Report of the Committee on a Recommended Standard Form of Table for Electric Lever Interlocking.

APPENDIX II, SHEET 2. Recommended standard form of table for electric lever interlocking

WRITTEN COMMENT.

SHEET 3.

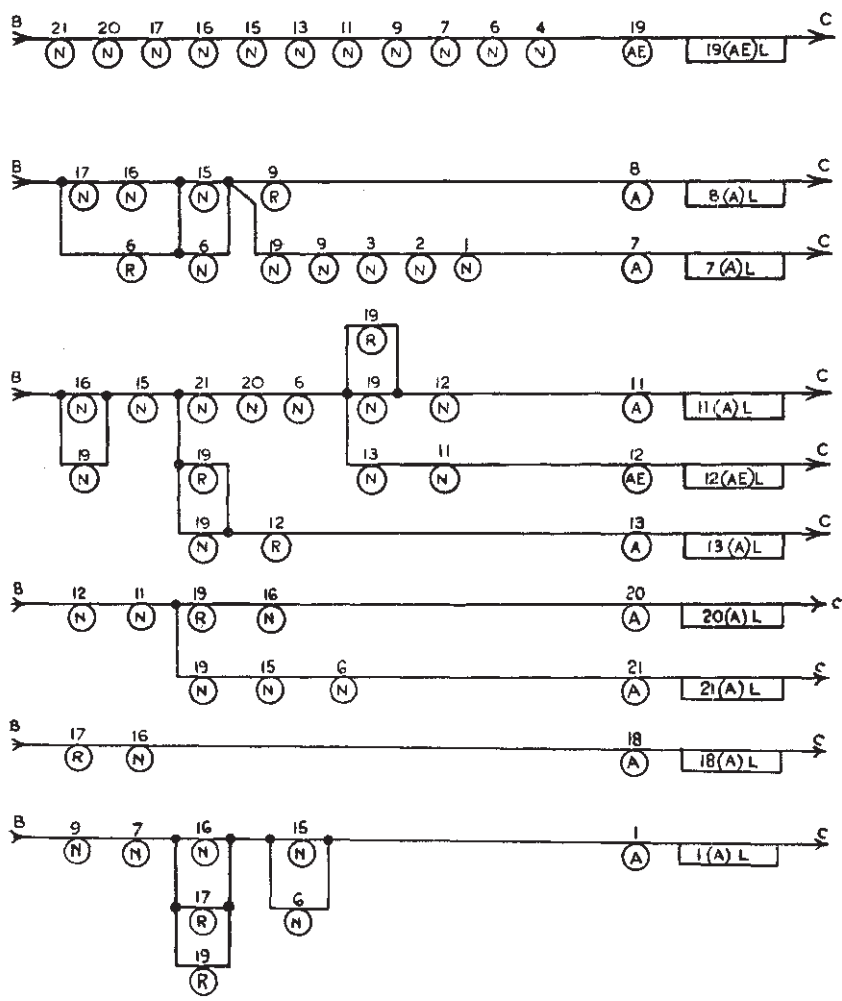
Mr. F. J. Dutton thought the word "normal" on line No. 2, item 5, column 1, should be deleted, as the lever lock was not necessarily a normal one. This was shown by the example at the right hand side which showed both AE and AB type locks. He also suggested that columns 4 and 5 should be amalgamated and the square brackets dispensed with. This would simplify the table and render it free from ambiguity, as would be appreciated on comparing the locking at present shown therein against lever No. 4 with that proposed by him, as follows:—

He agreed that any such table ought to be readily translatable into circuits and thought it would be found that his proposed modification was an improvement in this respect. For example, the table in the report showed two items for 6R although there was only one reverse contact in the circuit. Another argument in support of the proposed alteration was that column 7 included both conditional and unconditional controls but was not sub-divided. Conditional controls could be enclosed in the round brackets and the letters N and R used inside them, as required, it being assumed that all figures not enclosed by brackets referred to the normal

position. Mr. Dutton would also suggest that the word "reverse" be replaced by "releases" in column 6, because that column was used for the converse of releases and would then be in accordance with the standard mechanical locking table used by his company. When referring to the layout diagram in connection with column 8 it would be seen that 6 should be locked by 7 or 8, whereas it was obviously free when 17 was normal. It was noted that 7 and 8 locking 6 both ways had been deliberately omitted but its equivalent had not been substituted. Apparently this column would only be necessary for the converses of special locking having two normal conditions. An example of that could not, however, be cited from the layout in question. It was the practice on Mr. Dutton's division to mark superfluous locking by a small "s" above the figure and it appeared desirable to adopt this method in this new table. Presumably the use of the short thick line was optional.

Mr. F. Horler, chairman of the committee, in reply to the comments received on the report, said it must be appreciated that the recommended form of table was not the only one that would be of practical value. Installations had been carried out from tables of extremely divergent character. The members of the committee were widely representative and at the outset of the work contributed their individually developed ideas. Each conceded something in the discussions which followed. The terms used for the column headings were given close consideration. The use of the verb "to release," so long established in mechanical interlocking as meaning precedence in operation, created a special difficulty, since it there clashed with the sense in which they understood it in electrical interlocking. There was no adequate alternative. This was said with all deference to Mr. Carslake's comments, which suggested using the term "requires." The verb "to lock" was a term not strictly applicable to electric interlocking. Of two levers, of which only one could be reversed at one time, they spoke of one being released by the other in the normal position, but of two levers, one of which could be reversed only if the other was first reversed, they spoke of one being released by the other in the reversed position. There were other terms familiar to them in mechanical interlocking which were not adopted in electrical interlocking. "Bothway lock," for instance, was superseded by the specific "N" or "R." In conditional locking the expressions "when" and "unless" were abandoned, all conditions being stated as alternative releases, the word "or" being used exclusively to express one, which should be particularly appreciated by the circuit designer. Mr. F. J. Dutton had criticised the use of the word "normal" on line No. 2, item 5, column 1, but the word actually used was "normally" and was meant to refer to the manner,—as much as

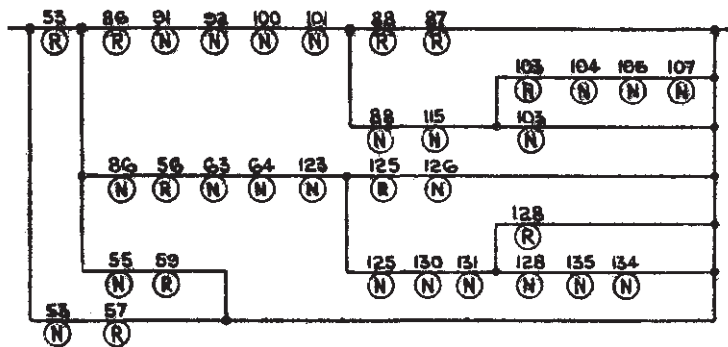
to say "in the ordinary way"—rather than the position in which the locking was operative. In view of the construction that could be placed on it, however, no doubt the committee would not be averse to its deletion. Both Mr. Dutton and Mr. Carslake suggested the merging of columns 4 and 5, considering that to do so would simplify the table and render it free from ambiguity. It would be agreed that in the example given by Mr. Dutton there was a case where there was at least as much to be said for as against the arrangement. That, however, was because there was so little interlocking expressed in it. In a big layout, where the conditional locking was complicated and far reaching, there could be no doubt that the divisions advocated by the committee were simpler. The accompanying diagram was an actual circuit of alternative releases.

It would be an interesting recreation to set this down in tabular form in its briefest terms, that was to say without twice using any lever-number-position. It could be written down systematically and intelligibly in the way described by the committee, but that would not, it was admitted, be the most concise one. All the direct releases taken from column 4 would appear in the circuit at one end of the alternatives. Column 7 had not been sub-divided because the entries in it would be relatively small. It did not seem necessary to use the suffix " N " for normal releases, whether enclosed in brackets or not, and that opinion was based on practice. The committee had not recommended any means of marking superfluous interlocking in the table. When electrical interlocking became superfluous it was better to remove the wiring. The thick underline was not intended for indicating
